NO.	BULLETIN #	DATE
5	BULLETIN #6	08/26/2022
4	ISSUED FOR PERMIT REVISIONS	06/03/2022
3	BULLETIN #1	02/07/2022
2	ISSUED FOR PERMIT REVISIONS	01/20/2022
1	ISSUED FOR PERMIT REVISIONS	01/10/2022
0	ISSUE FOR BID/PERMIT	01/15/2021
Job Number		022527-000

OAK PARK
COMMUNITY
RECREATION CENTER
229 MADISON STREET
OAK PARK, IL 60302

SITE DETAILS

L10-07

1 ENTRY PLAZA LAYOUT PLAN
1/2" = 1'-0"

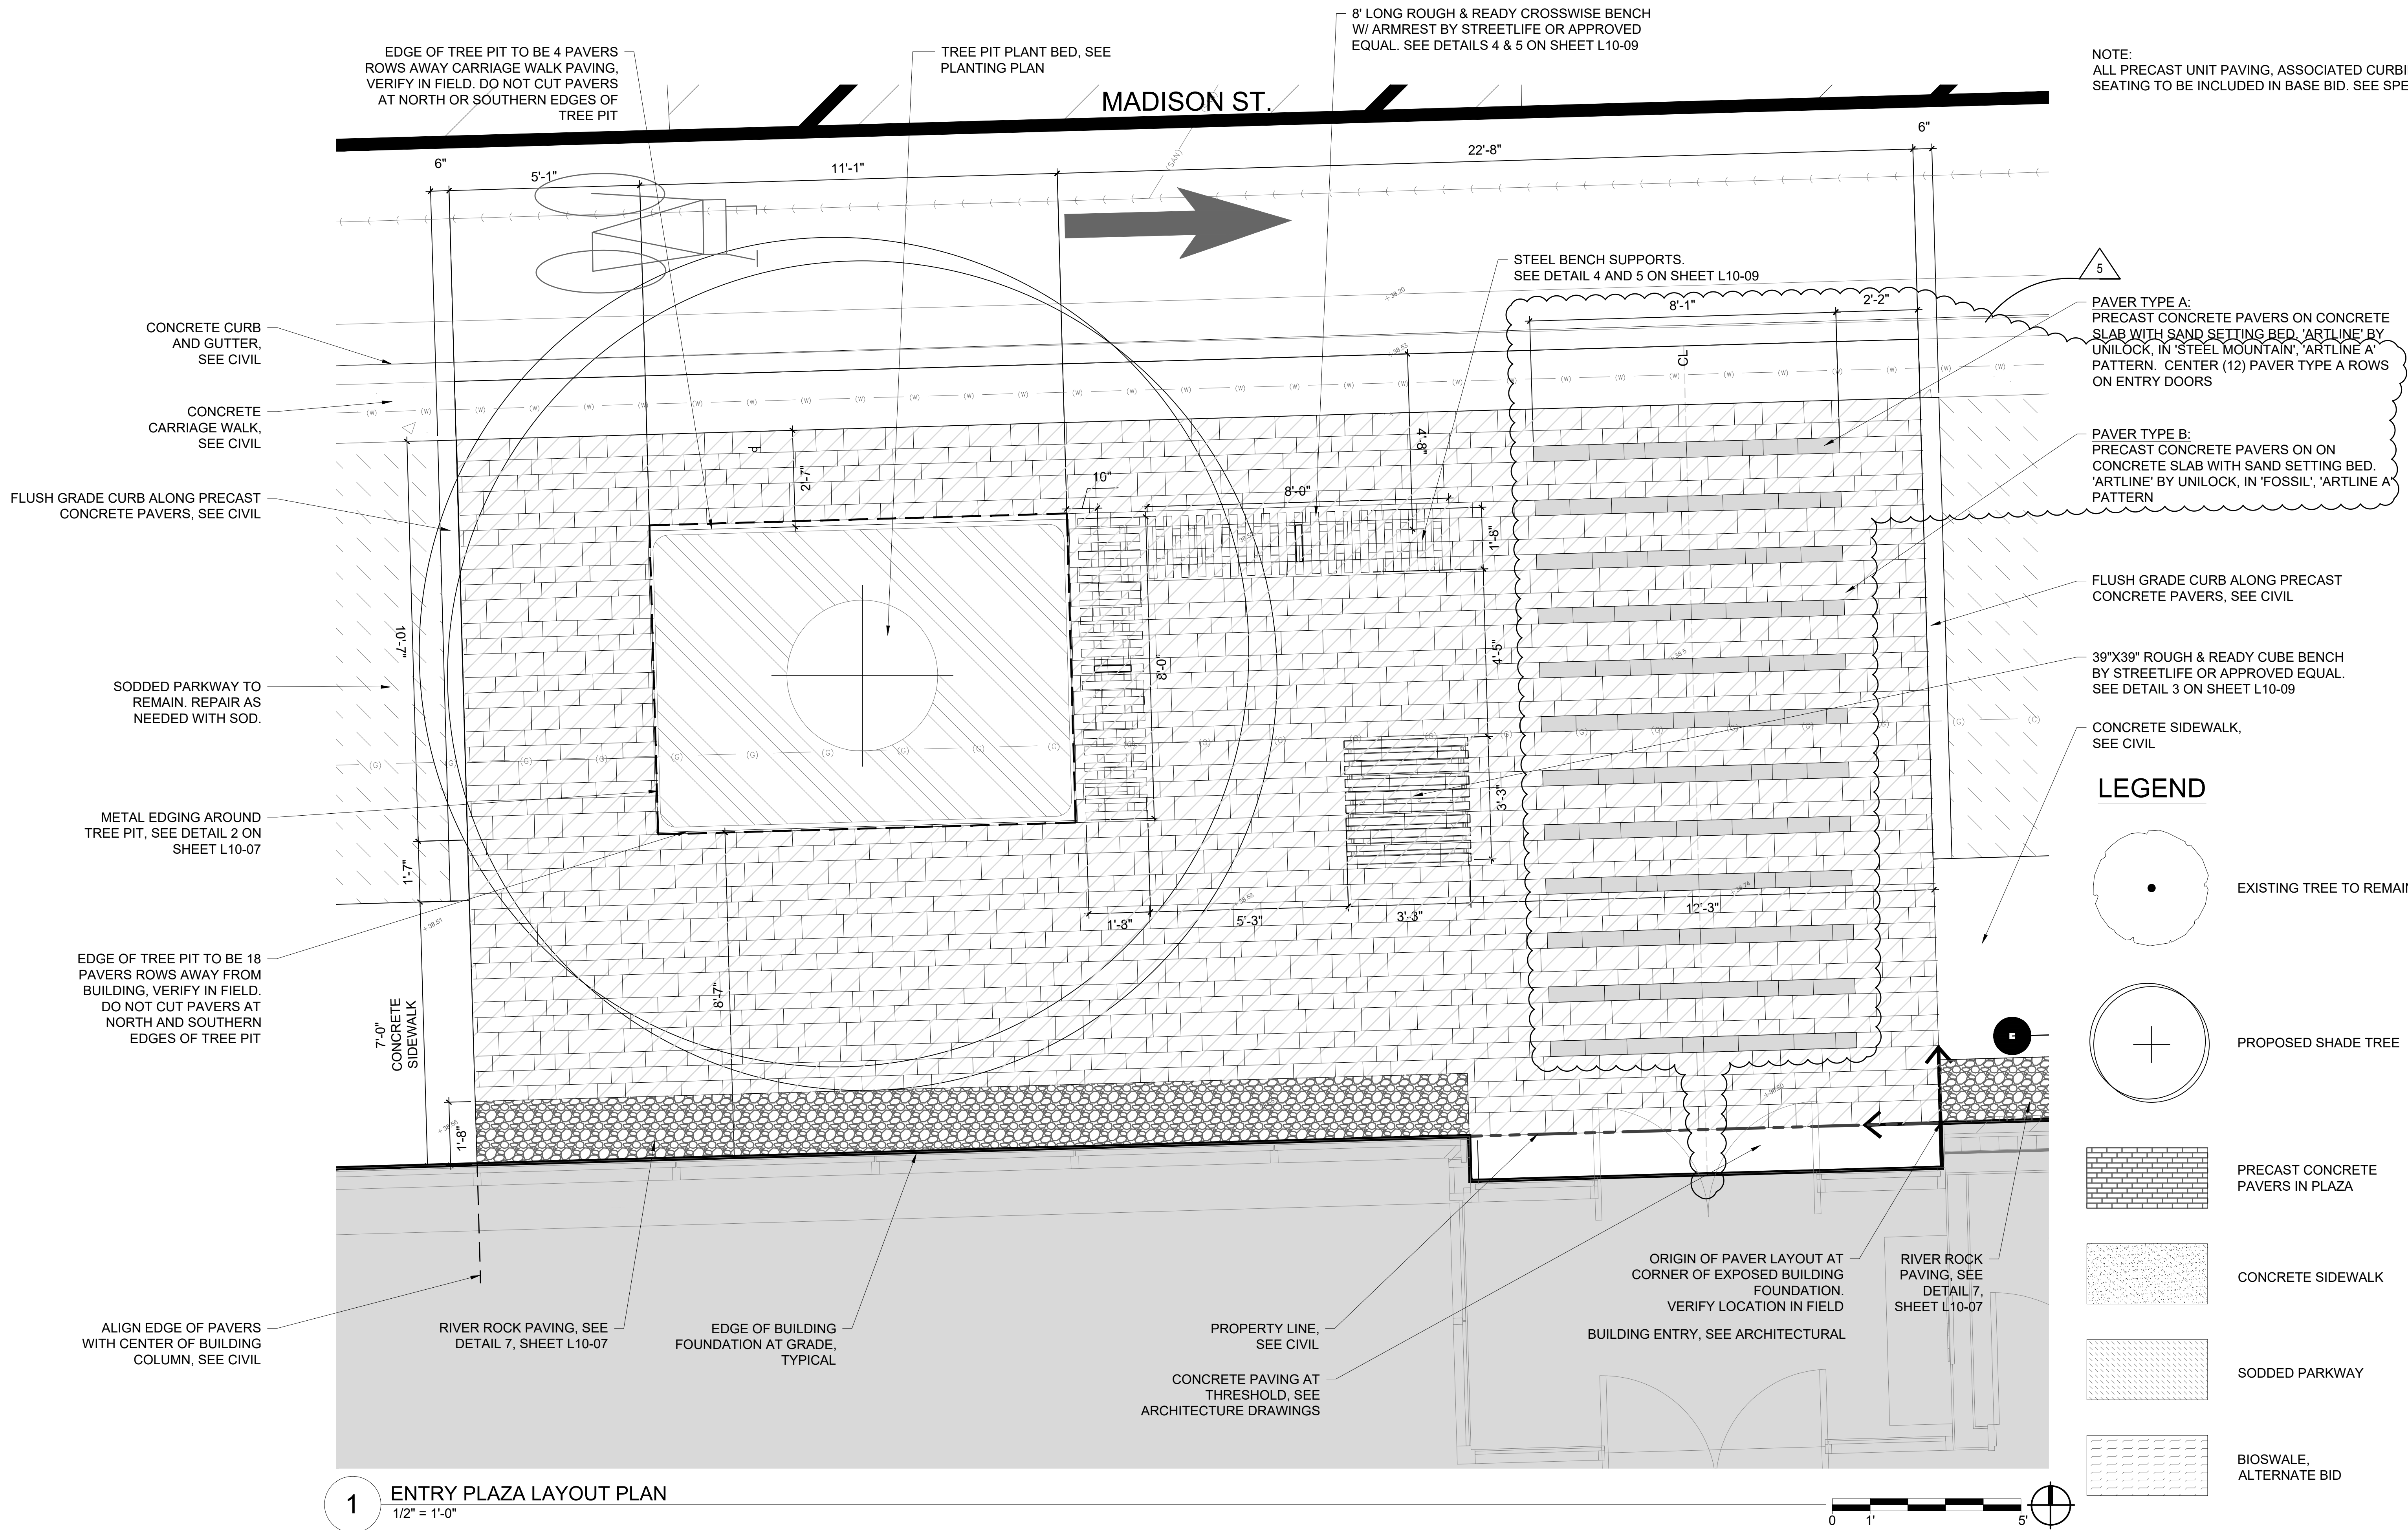
EDGE OF PAVERS AT EAST
END OF NORTH ENTRY
PLAZA. PAVERS TO BE CUT
NO SHORTER THAN 1/3
LENGTH ALONG THIS SIDE
